MSEX2002A-03

S E R V I C E N O T E

MSEX2002A – Oscilloscope, Mixed Signal, 2+8 Channel,
70MHz

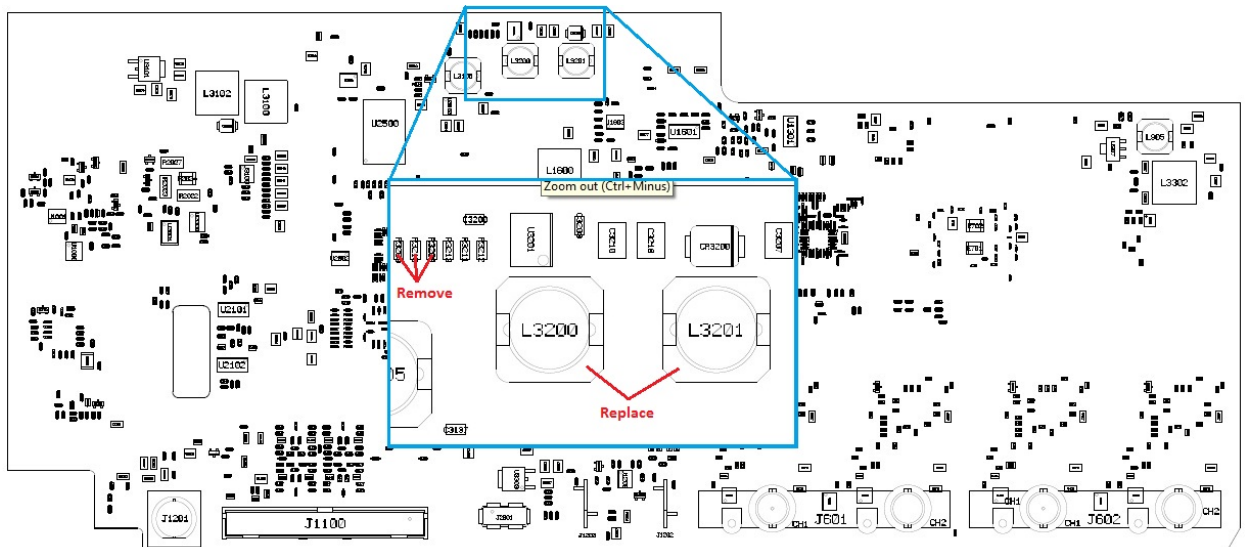
With the oscilloscope power turned on and while under normal operation, the unit emits a hissing noise.

2. As the picture indicates, remove the three resistors (0699-7209, 1 Ohm) located at R3208, R3209, and R3210. They are not to be replaced.
3. Remove as well the two inductors (9140-6474, 100uH) located at L3200 and L3201 and replace them with inductors with part number 9140-6151 (68 uH).
4. Re-assemble to the point where the unit could be powered up to verify that the hissing is indeed gone. If the hissing is not gone, please, check modifications.
5. When the hissing is gone, put oscilloscope back together.
